# Pentium<sup>®</sup> Processor Specification Update

Release Date: January, 1997

Order Number 242480-024

## **21. Power-Up BIST Failure**

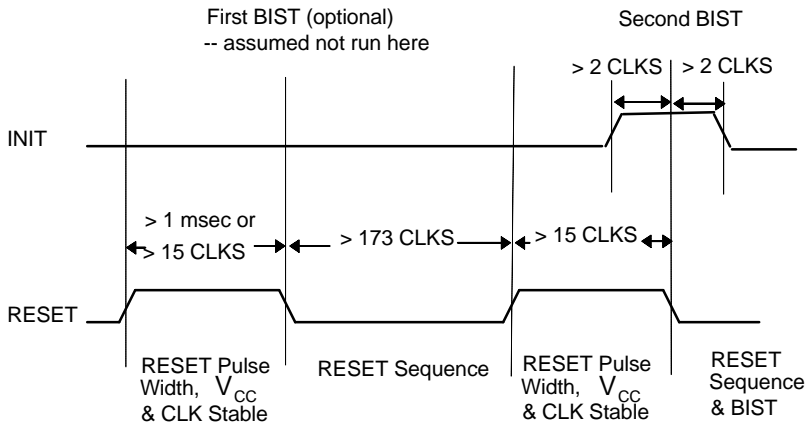
**PROBLEM:** The BIST (Built In Self Test) feature may fail.

**IMPLICATION:** Upon completion of BIST, a false failure may be reported. That is, a non-zero value may be returned in the EAX register, even though the part is operating correctly. As such, this erratum has no other product or system implications and is fully functional. To date, all observed false failures have returned a value of 20000H in EAX.

1. Invoke a double RESET — All false BIST failures have occurred during cold RESET. In order to accurately execute BIST, a double RESET sequence may be performed as shown in the figure below:

2. Use RUNBIST — BIST may be run through the RUNBIST instruction, available through the Test Access Port as documented. In this fashion, BIST will return correct values.

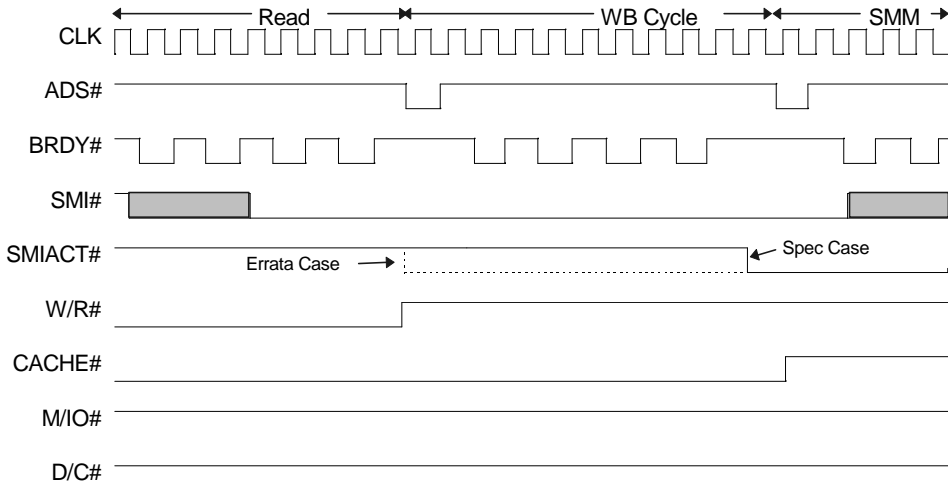
<i>Stop Grant special cycle</i>	If BOFF# is used to back off a Stop Grant special cycle, the processor may hang. Stop Grant and Stop Clock states for low power consumption cannot be used.
<i>AutoHALT special cycle</i>	If BOFF# is used to back off a AutoHALT special cycle, the processor may hang. This means that the lower power AutoHALT state is not usable. This does not affect the normal HALT state, entered with the HLT instruction though.
<i>INIT asserted while there is a memory mapped APIC register access</i>	If BOFF# is used to back off a memory mapped APIC register access (read or write) while an INIT is pending, the processor may hang. The INIT would only be used during a switch from Protected to Real mode, which is normally associated with a system reboot. In the processor lockup occurs a reboot may have to be performed via system powerdown.

**WORKAROUND:** Restrict the use of BOFF# for the described events. In addition, the SMI# pending event can be eliminated by locating SMRAM so that it does not shadow standard memory and does not require SMIACT# for memory decode. The OUT or Serializing instruction events are also eliminated if the next instruction does not depend on the result of the event before executing the instruction. The Stop Grant special cycle event is also eliminated by not asserting STPCLK#. The AutoHALT special cycle event is also eliminated by disabling AUTOHALT (set TR12.AHD bit to '1').

## **11. *Future Pentium® OverDrive® Processor FERR# Contention in Two-Socket Systems***

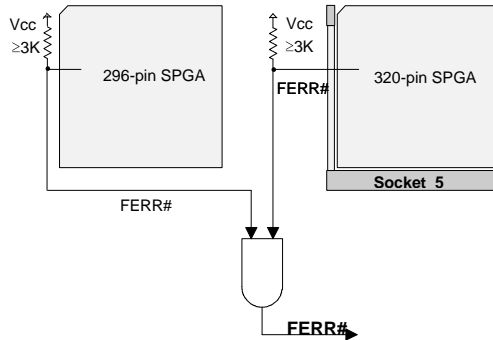
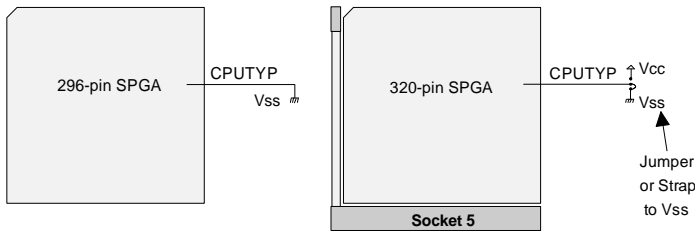
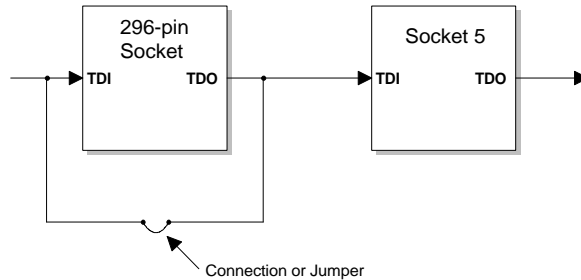
**PROBLEM:** When the future Pentium OverDrive® processor is plugged into Socket 5 of a two socket 75-, 90-, or 100-MHz Pentium processor system, the OEM processor shuts down following RESET to allow the OverDrive processor to drive the bus. In this case, the FERR# output of the 75-, 90-, and 100-MHz Pentium processor continues to be driven HIGH (inactive).

**IMPLICATION:** If the system uses the FERR# output of the OEM processor, and has the signal connected together between the two sockets (296-pin SPGA OEM socket and 320-pin Socket 5), contention on this signal is certain since the future Pentium OverDrive processor, when placed into Socket 5, will also drive this output. This signal contention can cause component and even board reliability issues.

An external AND gate may be used to combine the outputs of the FERR# signals from the two sockets. A pullup resistor ( $\geq 3K\Omega$ ) is required on the FERR# output from both of the sockets in order to allow proper operation of both the dual processor and the future Pentium OverDrive processor. See the following figure:

2. **Upgradability by modifying a two socket system to be a single socket system:** This workaround involves modifying a design that includes two socket sites (296-pin SPGA and 320-pin Socket 5) such that it effectively becomes a single socket design.

A dual processing two socket system must have CPUTYP tied to  $V_{SS}$  on the 296-pin SPGA OEM socket, and tied to  $V_{CC}$  on Socket 5 (320-pin SPGA). This workaround includes inserting a jumper on the Socket 5 CPUTYP signal (or strapping Socket 5 CPUTYP directly to  $V_{SS}$ ) to make this the primary processor site. The system would then effectively become a single-socket design. NOTE: If a jumper is used, it must be set by the OEM prior to system sale (not by the end-user at the time of the future Pentium OverDrive processor purchase and installation). This jumper would set the CPUTYP signal on Socket 5 to  $V_{SS}$ . If the same board design is used for dual processing, this jumper (or strapping option) may be set to  $V_{CC}$  for those systems, as shown in the following figure:

## **68. Asserting TRST# Pin or Issuing JTAG Instructions Does not Exit TAP Hi-Z State**

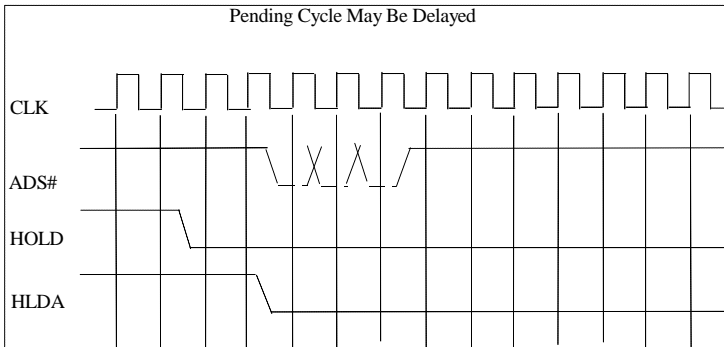
**PROBLEM:** The *Pentium<sup>®</sup> Processor Family Developer's Manual*, Volume 1 states that the TAP Hi-Z state can be terminated by resetting the TAP with the TRST# pin, by issuing another TAP instruction, or by entering the Test\_Logic\_Reset state. However, the indication that the processor has entered the TAP Hi-Z state is maintained until the next RESET. Therefore by using the above methods alone, the TAP Hi-Z state can not be terminated.

**IMPLICATION:** When the TAP Hi-Z instruction is enabled and executed, using the methods described in the *Pentium<sup>®</sup> Processor Family Developer's Manual*, Volume 1 may not terminate the Hi-Z state.

**WORKAROUND:** To exit TAP Hi-Z state, in addition to the methods described above, the processor needs to be RESET as well.

## **69. ADS# May be Delayed After HLDA Deassertion**

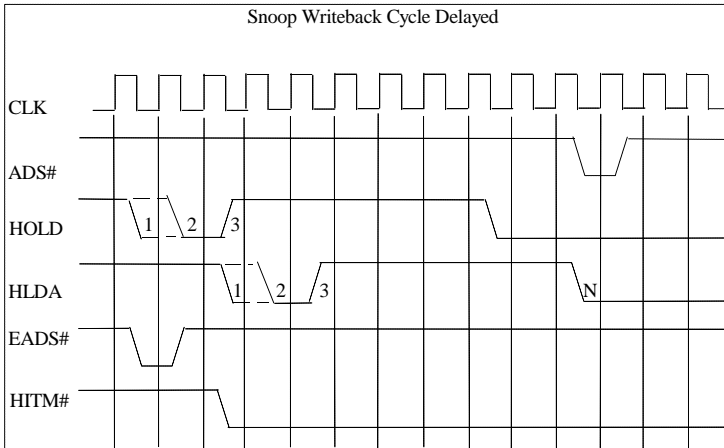
**PROBLEM:** The Pentium processor typically starts a pending bus cycle on the same clock that HLDA is deasserted. However, it may be delayed by as many as two clocks. See the diagram below.

In two cases, for example, if HOLD is deasserted for one clock (i.e., clock 2) or two clocks (i.e., clocks 1 & 2) and then reasserted, the window may not be large enough to start a pending snoop writeback cycle. The writeback cycle may be delayed until the HLDA is deasserted again (i.e., clock N). See diagram below.

### 3DP. External Snooping with AHOLD Asserted May Cause Processor to Hang

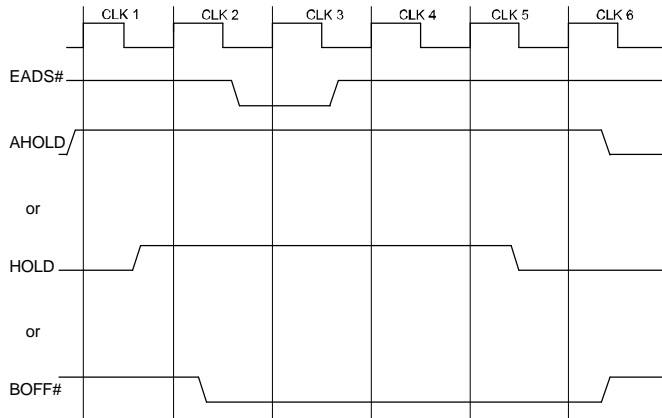
**IMPLICATION:** If a memory write or memory read cycle is pending on the bus and an external snoop occurs, one of the processors may hang.

1. Ensure that NA#/BRDY# is asserted before, or after the “critical period”. (the critical period is the two CLK period after EADS# is sampled active.)  
or
2. Ensure that AHOLD is held high for a minimum of three clocks after EADS# has been sampled active.  
See the following figure.  
Or

3. Drive HOLD for two clocks after the EADS# was sampled active. Removal of HOLD can be done without regard to the HLDA signal. See the following figure.

#### 4DP. Address Parity Check Not Supported in Dual Processing Mode

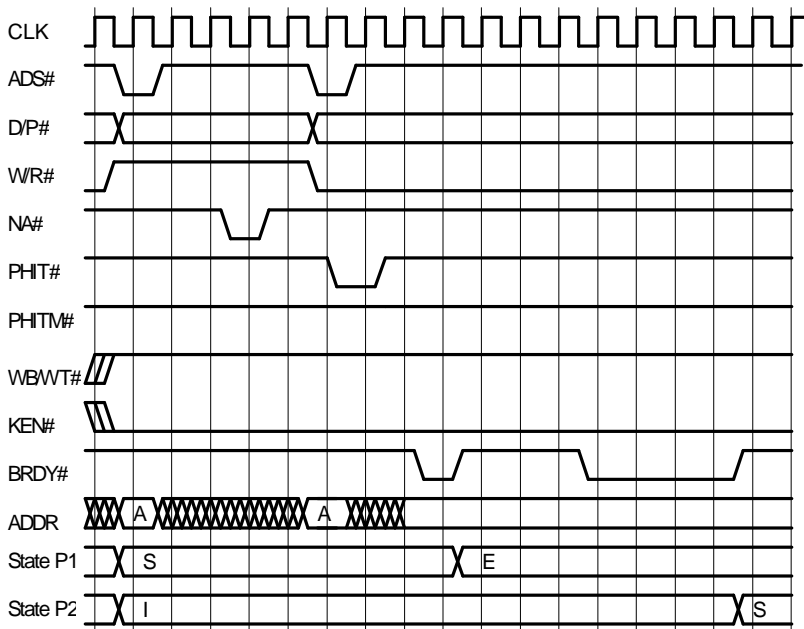
**PROBLEM:** This is a dual processor erratum: There is a very short setup and hold time for the address bus lines in Dual Processing mode to support the single clock interprocessor snoop response required for cache coherency. In this case the 3ns setup specification is enough for the address to propagate to the cache but it does not allow enough time for the address to propagate to the parity calculation circuits. There is a chance that the APCHK# line will spuriously go active showing a parity error on the address bus.

**IMPLICATION:** Internal measurements of these address signals show that if the 3ns spec is met, the addresses will be latched correctly. Since the parity portion of the circuitry does not meet this timing there is no way to guarantee the APCHK# output is valid. Systems using the APCHK# pin will perform the APCHK# interrupt error routines.

**WORKAROUND:** Designs based on the 82430NX PCiset and other chip sets which ignore APCHK# in a dual processor environment are therefore not affected. If the address setup ( $t_{s3}$ ) and Maximum Valid Delay ( $t_6$ ) timings in the *Pentium® Processor Family Developer's Manual*, Volume 1, Section 23.4.5.2 and 23.4.5.3 are followed, this erratum will not apply to C-step components and future steppings.

## **9DP. Double Issuance of Read Cycles**

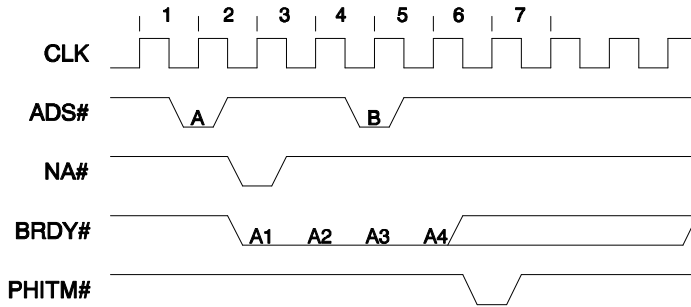
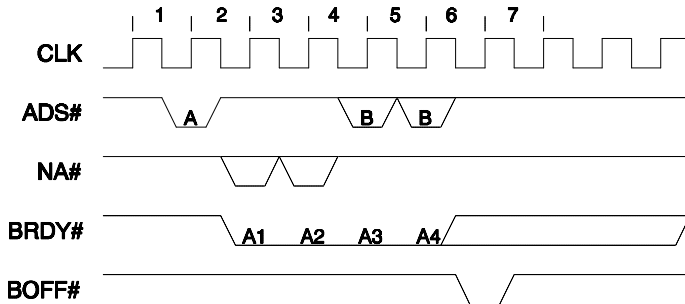
**PROBLEM:** In a dual processing environment, a memory read cycle (either data read or prefetch) may occur twice. The second read cycle may cause mis-operation of the CPU.

This problem occurs only in dual processing systems with a bus/core ratio of 2/3. For this to occur, pipelining must be enabled with some or all read cycles occurring in zero wait states.

- The processor issues read cycle A which may be pipelined into an earlier (not shown) cycle.
- Cycle A will be completed by the system as a 2-1-1-1 (zero wait state) cycle.
- One or two clocks after issuance of the ADS#, NA# is asserted by the system.
- A pipelined cycle (B) is asserted by the MRM in either clock 4 or clock 5.
- Cycle A completes on the bus in clock 5.
- One clock later, BOFF# is issued by the system.

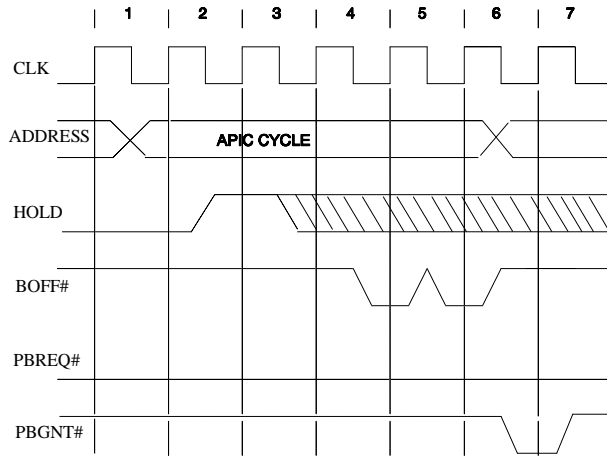
**IMPLICATION:** The specification states that EADS# is ignored while the processor is driving the bus. Occurrence of this erratum means that unnecessary invalidations and writeback cycles may be performed resulting in sub-optimal performance.

**WORKAROUND:** The system should not assert EADS# while the CPU owns the bus. Designs based on the 82430NX PCIsset and other chip sets which do not assert EADS# while the CPU owns the bus are therefore not affected.

### 13DP. System Hang After Hold During Local APIC 2<sup>nd</sup> INTA Cycle

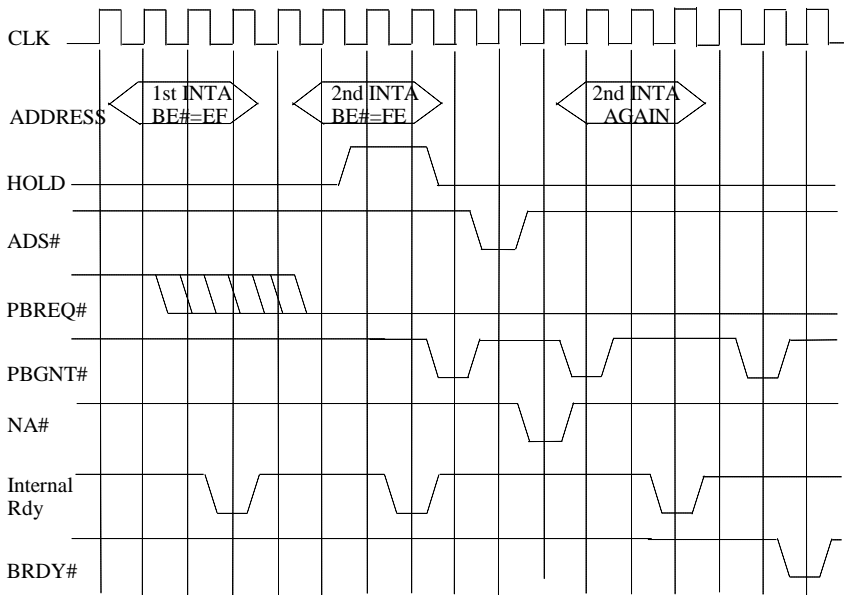
**PROBLEM:** In a dual processor system, the following sequence of events may cause the system to lock up:

1. One of the CPU's (i.e. CPU A) initiates the first and second internal APIC INTA cycles. The INTA cycles are not driven on the external bus. CPU B requests ownership of the bus by asserting PBREQ#.
2. HOLD is asserted during the 2<sup>nd</sup> INTA cycle and PBGNT# is asserted.
3. CPU B issues a read or write cycle and receives NA# before completion of the cycle. The bus is granted back to CPU A.
4. CPU A reissues the second INTA cycle and grants the bus to CPU B.
5. CPU A hangs because the internal Rdy# and BRDY# were recognized out of order.

## 28. PPGA Package Dimensions

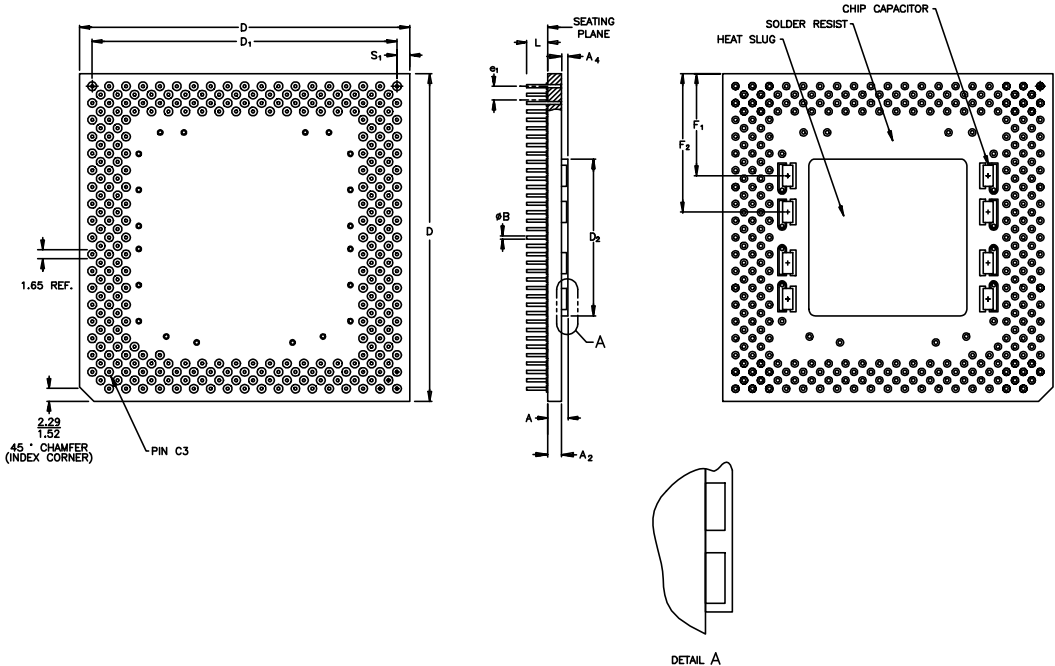
Package dimensions for the Plastic Pin Grid Array (PPGA) package are as follows. This information will be added to the *Pentium® Processor Family Developer's Manual*, Volume 1, Chapter 25.

Figure 47-1. Maximum Overshoot Level, Overshoot Threshold Level, and Overshoot Threshold Duration

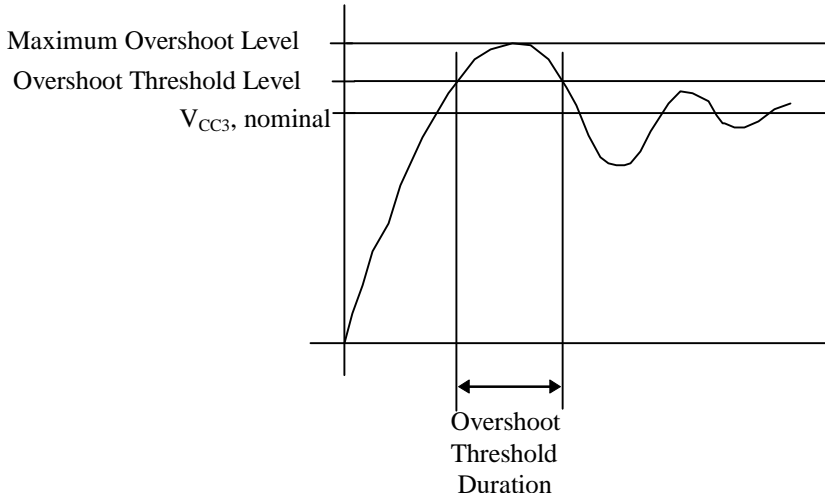
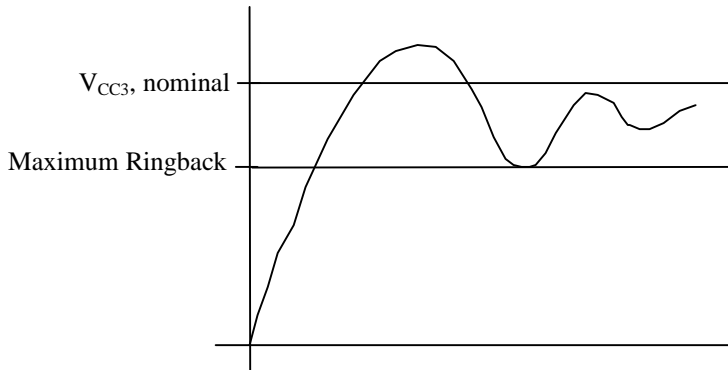
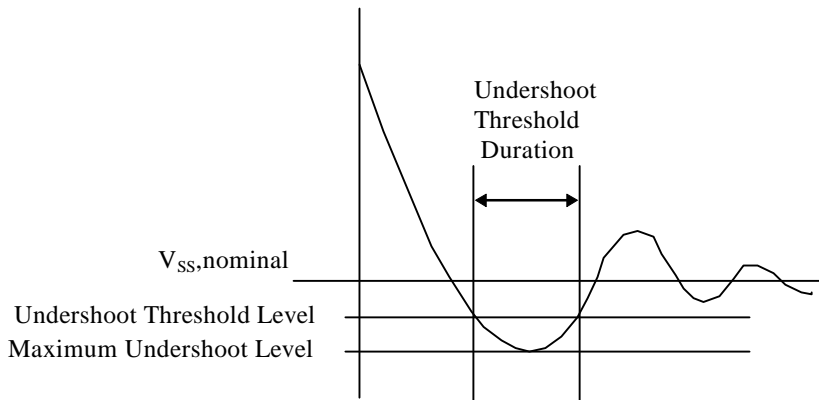
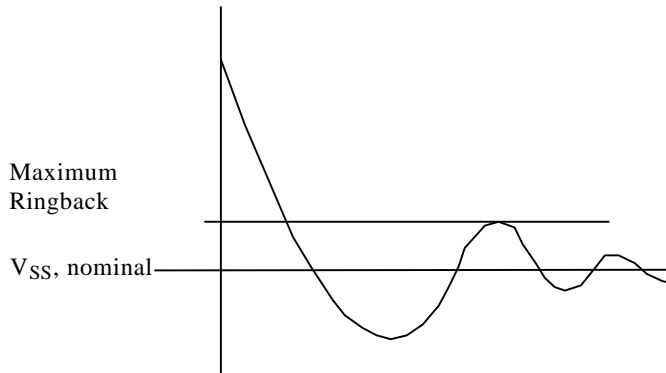
**MAXIMUM RINGBACK SPECIFICATION:** The maximum ringback of CLK/PICCLK associated with their high states (overshoot) must not drop below  $V_{CC3} - 0.8V$  as shown in Figure 47-2. Similarly, the maximum ringback of CLK/PICCLK associated with their low states (undershoot) must not exceed  $0.8V$  as shown in Figure 47-4.

These overshoot and undershoot specifications are illustrated graphically in Figure 47-1 to Figure 47-4.
